PLANNING, ZONING, & BUILDING DEPARTMENT  
PZ&B Staff Combination Memorandum: Architectural Commission and Town Council

SUBJECT: ARC-24-0133 (ZON-24-0074) 410 SEABREEZE AVE (COMBO)

MEETING: JANUARY 29, 2025, ARCOM  
FEBRUARY 12, 2025, TC

*Existing and Proposed Rear (South) Elevations*

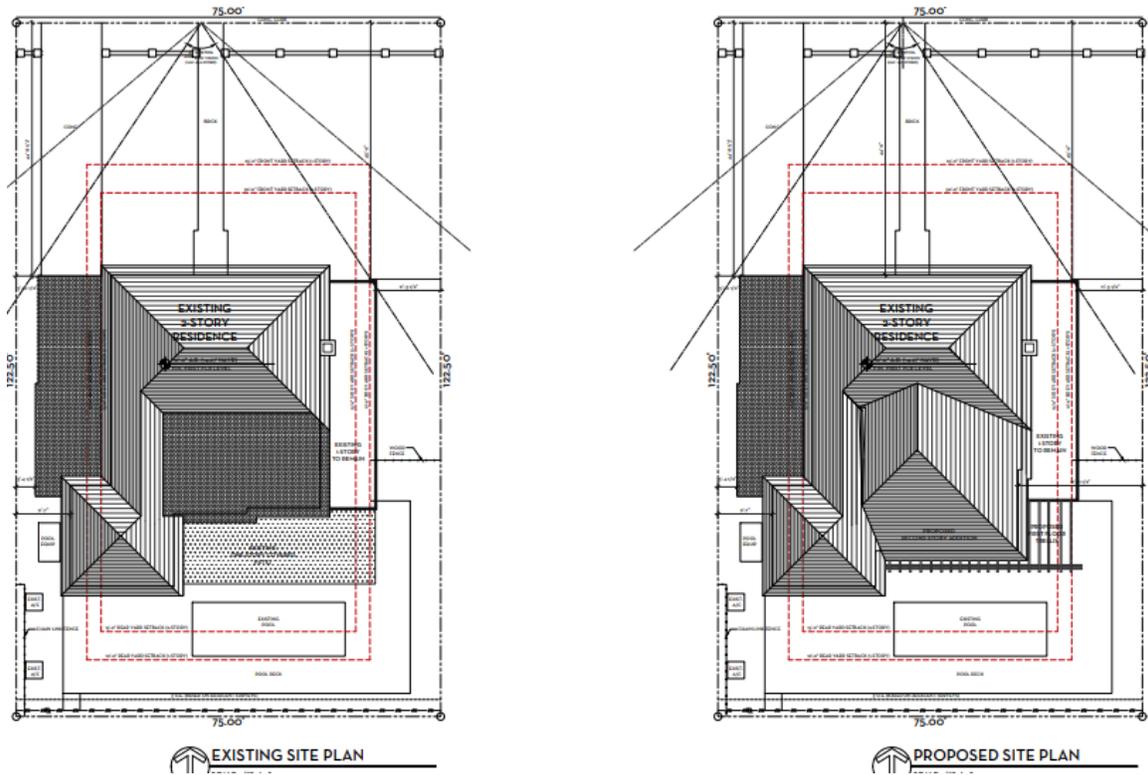
The application is for a proposed addition. The proposed improvements to the structure are within the existing footprint. The applicant is proposing a second story addition at the existing second floor balcony on the rear east side of the structure. The addition is relatively small (178 SF); however, variances are required to achieve the scope of work. The roof of the addition will be a hip that ties into the existing roof surfaced in matching tile. This will eliminate the currently flat roof portion of the house. Exterior finishes include wood siding to match the existing, multi lite windows flanked by painted wooden shutters and French Doors facing the rear.

As it pertains to VARIANCE 1, the rear of the structure is being removed to construct a more cohesive dining room and covered outdoor seating downstairs and a new dressing room upstairs. Due to the extent of demolition of this portion of the house the lot coverage will need to be revisited through a variance despite decreasing the lot coverage from 31.7% to 31.4%.

*Axonometric diagram of cubic content from rear.*

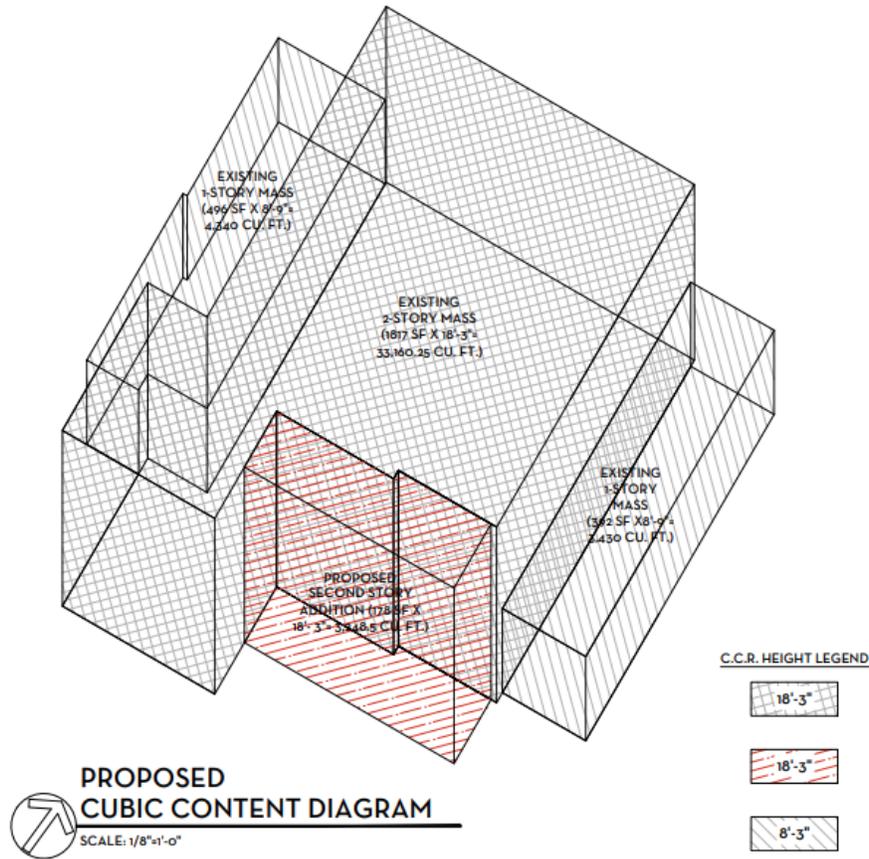
Variance 2 is to exceed the maximum cubic content ratio (CCR) permitted on site. As mentioned previously, the structure was built in the 1930s and therefore prior to today's zoning code. In 2008, the Town Council considered and granted a variance for a similar scope of work as it pertained to first and second floor additions to the nonconforming building, which permitted the expansion of the already nonconforming cubic content ratio (CCR) to the 4.59 amount existing today.

The size of the addition is approximately 178 SF at 18.3' in height for that volume, adding an additional 0.14CF of mass to the already nonconforming structure. The addition will not be visible from the public right of way nor the west elevation and matches the existing structure in style and materials. While the relatively small second floor addition seamlessly blends in with the architecture of the 1930's residence, it still remains as a variance and its approval needs to provide hardship in order for the Town Council to grant. Perhaps, as the Code reform continues to examine all aspect of the zoning code, the Town Council could provide specific direction on a lesser standard of approval for CCR on older residential buildings in the Town as a means of further incentivizing their retention.
